# SAN FRANCISCO UNIFIED SCHOOL DISTRICT FACILITIES DESIGN AND CONSTRUCTION

## ADDENDUM NO. 2

**PROJECT:** Computer Lab Renovation  
Lowell High School  
1101 Eucalyptus Drive  
San Francisco, CA 94132  
SFUSD Project Number: 697

**DATE:** July 23, 2014

Partial School Plan of Lowell HS  
Showing Location of Computer Lab, Panel C11 and IDF 2:

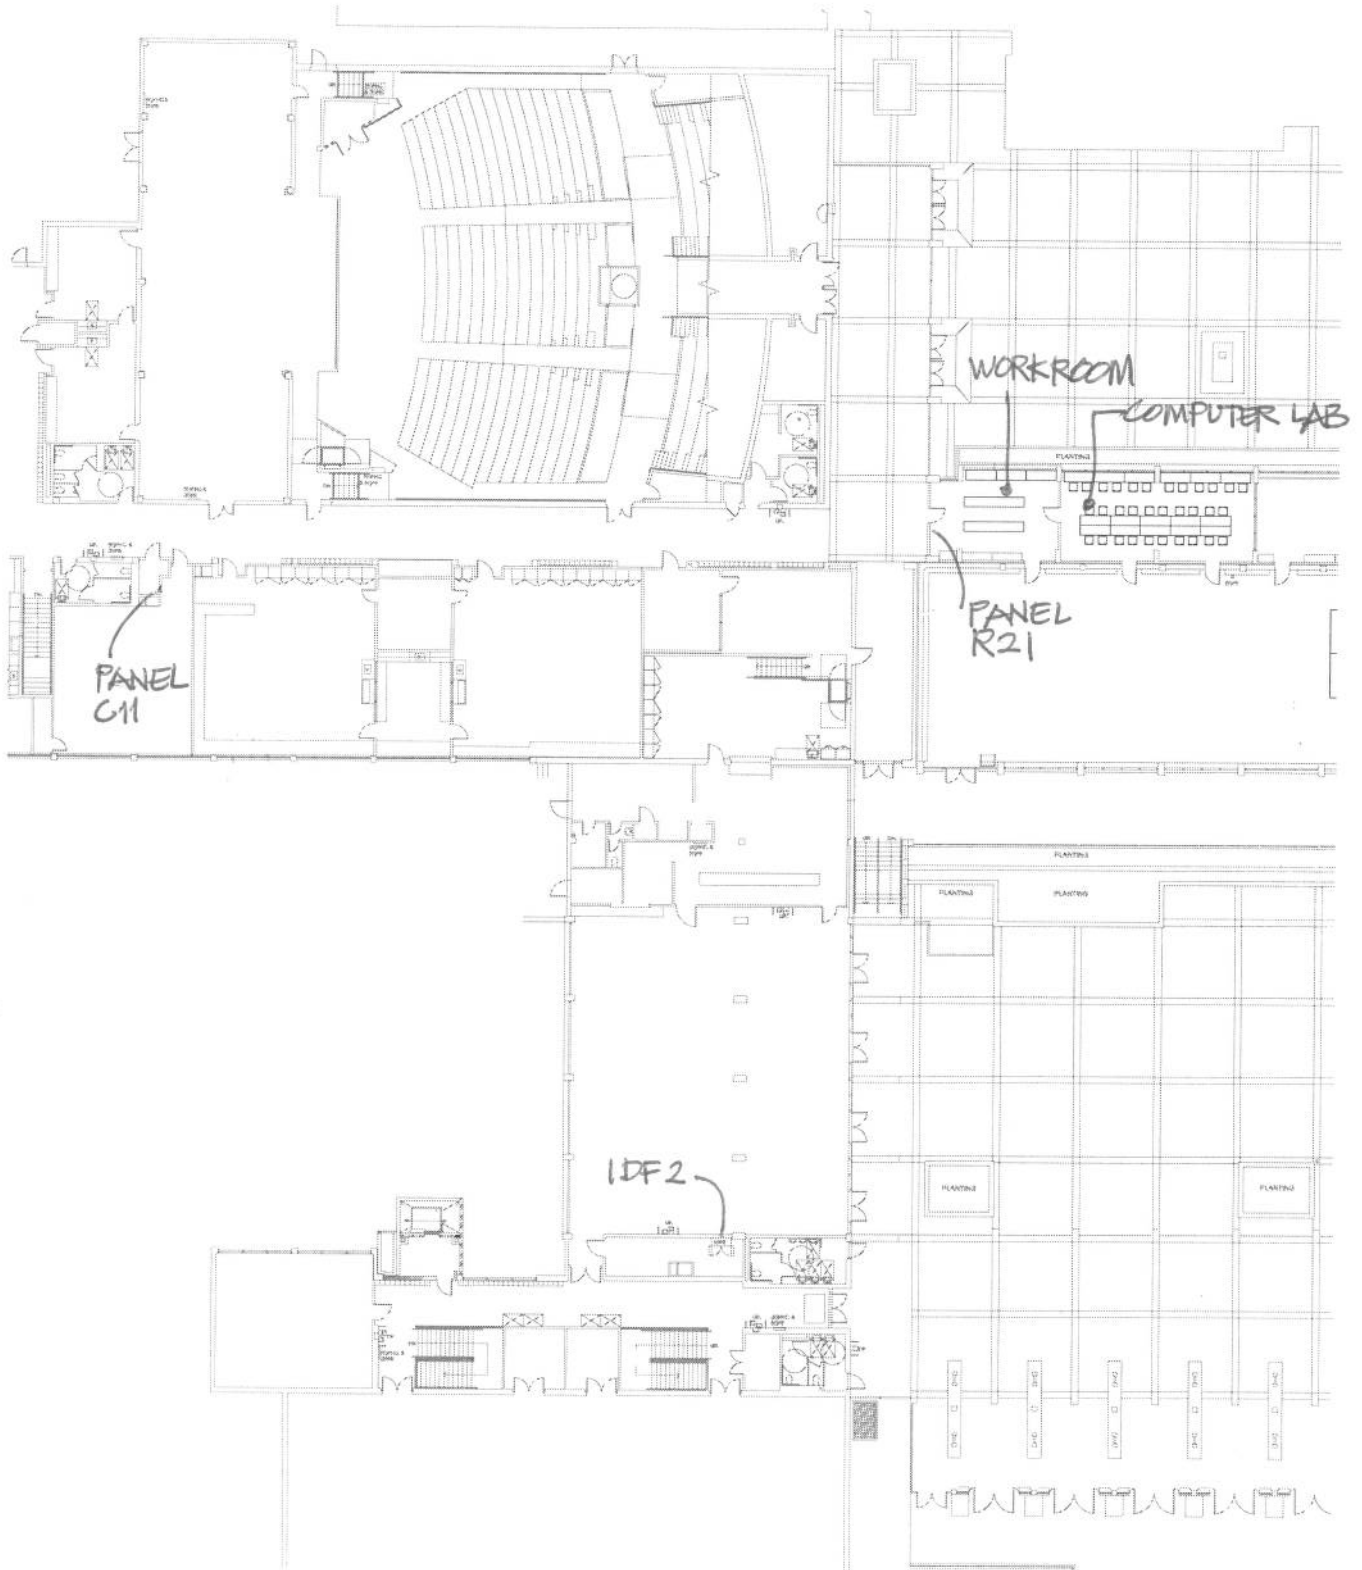
**Reference:** Drawing E2.0, First Floor Plans: Lighting, Power and Signal  
**Description:** Horizontal Linear Distance from Computer Lab Panel R21 to Panel C11 (Detail 3): 160 feet  
Horizontal Linear Distance from Computer Lab Low Voltage Pull Box to IDF 2 Cabinet (Detail 4): 185 feet.  
Contractor shall consider conduit and cable/wiring lengths for vertical and bend runs for estimating purposes in addition to the distances shown above. The contractor is still responsible in field verifying these distances to achieve an accurate account of what is required for the scope of work shown on the drawings and specifications. A partial school plan is attached for reference indicating locations of Panel C11 and IDF 2.
